# Arboricultural Assessment and Report

18 Mason Street, Warragul

Prepared for Housing Choices Australia

2 March 2023

## Appendix 2B: Design Review – TPZ Impact Plan: 18 Mason Street, Warragul – Proposed

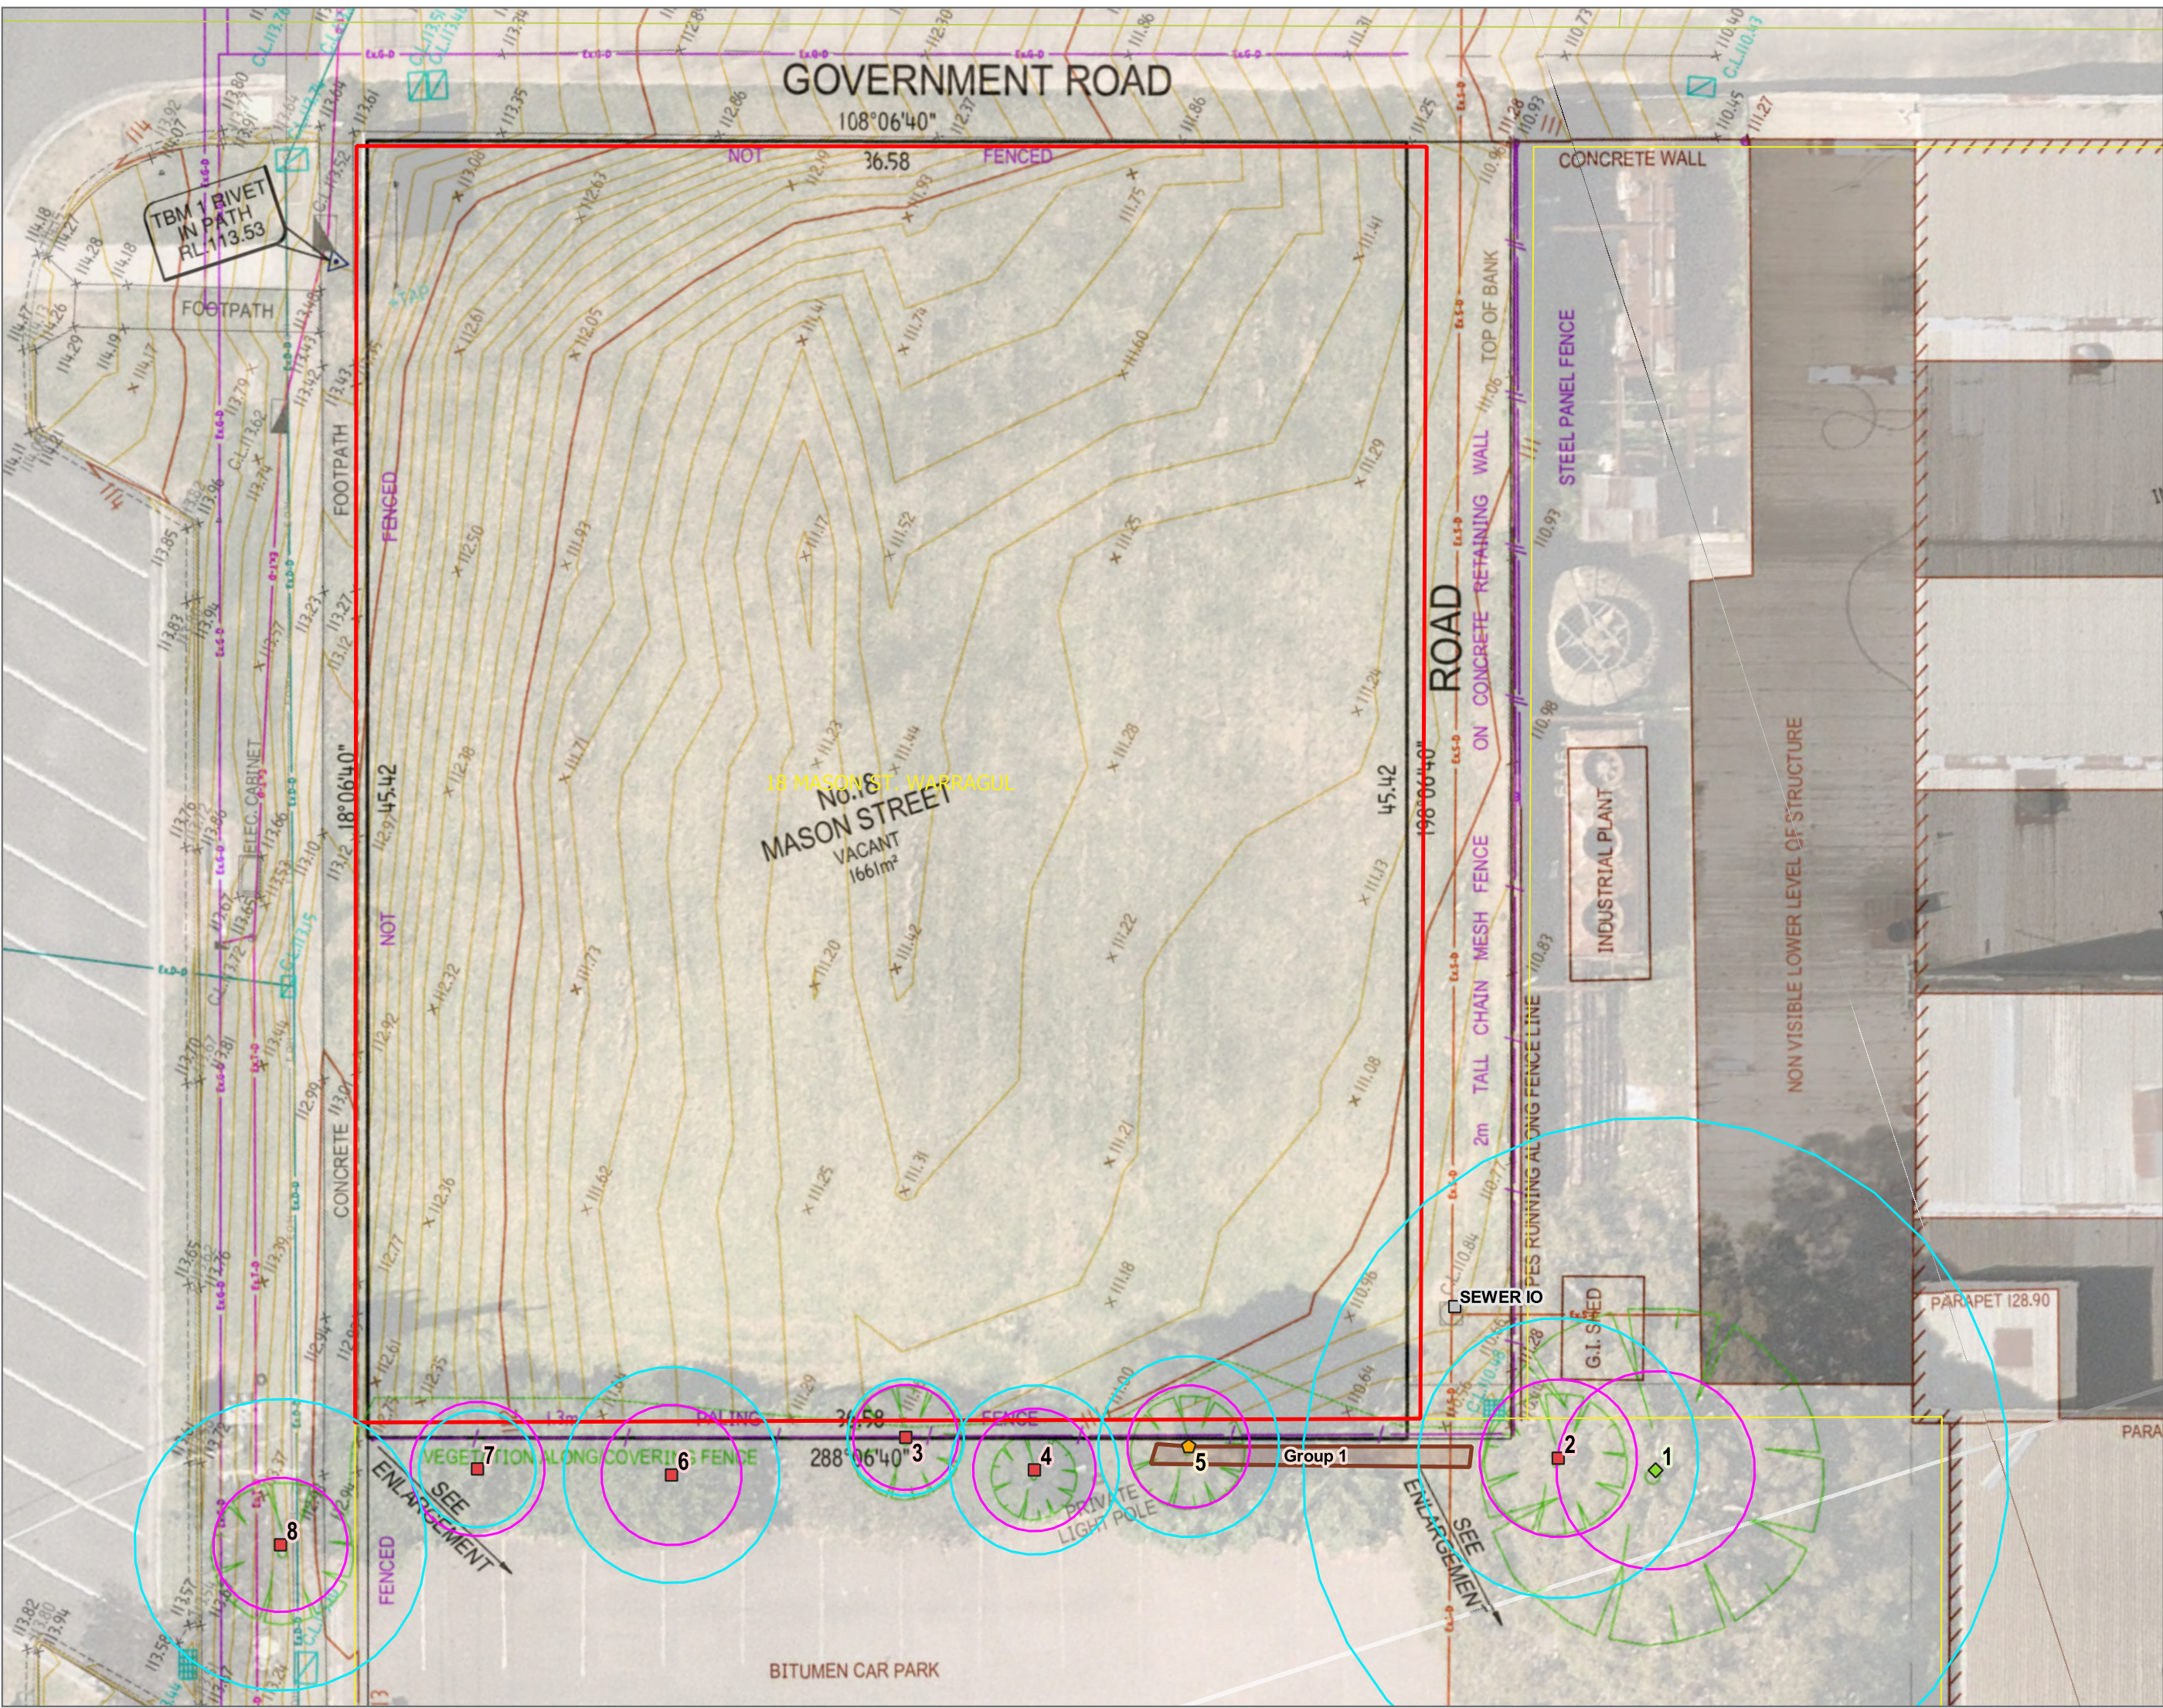
6.2 The basement will extend into the TPZ of Tree 1 by approximately 4%.

- The trees can be successfully sustained with appropriate TPZ fencing established 1 metre back from the proposed basement footprint.
- The shared path to be constructed in the paper road to the east of the site will notionally encroach the TPZ also. The path must adopt a shallow profile that does not require excavation greater than 100-150 mm depth for compacted sub-base material, in order to avoid any potential root damage. Any discrepancy between the finished surface level and natural ground would be made up with either mulch or uncompacted top-soil.

- 6.3 The SRZ of five (5) trees will be encroached by the building footprint which will cause the trees to decline and potentially become unstable.
- Four of these trees are invasive weeds that should be removed for sound environmental reasons.
  - Tree 5 is likely to be a stump re-sprout from an 80cm decaying Blackwood stump at the base with a canopy bias to the north over the subject site. As such the tree has a reduced useful life expectancy.

TPZ impact	Count	Tree numbers	comment
None	3	2, 8, G1	Tree 2 and Grp 1 unsuitable to retain.
Basement in TPZ <5%	1	1	Establish TPZ fencing 1 metre from basement footprint.
Basement in SRZ	5	3, 4, 5, 6, 7	Tree at risk of decline and failure. Trees generally unsuitable to retain
<b>Total</b>	<b>9</b>

- 6.4 Based on the perceived impacts to Tree 5 and the other low rated trees within the vegetation strip abutting the southern boundary it is recommended that removal and replacement of the Blackwood, Tree 5 and all of the other weed or poor quality trees is negotiated with the land-owner, on the basis that the boundary is so degraded, overgrown and weed infested that it is necessary for any future development to improve the fence and boundary plantings.
- Future planting species selection should be from trees that will tolerate shading and maintain a relatively narrow upright form.
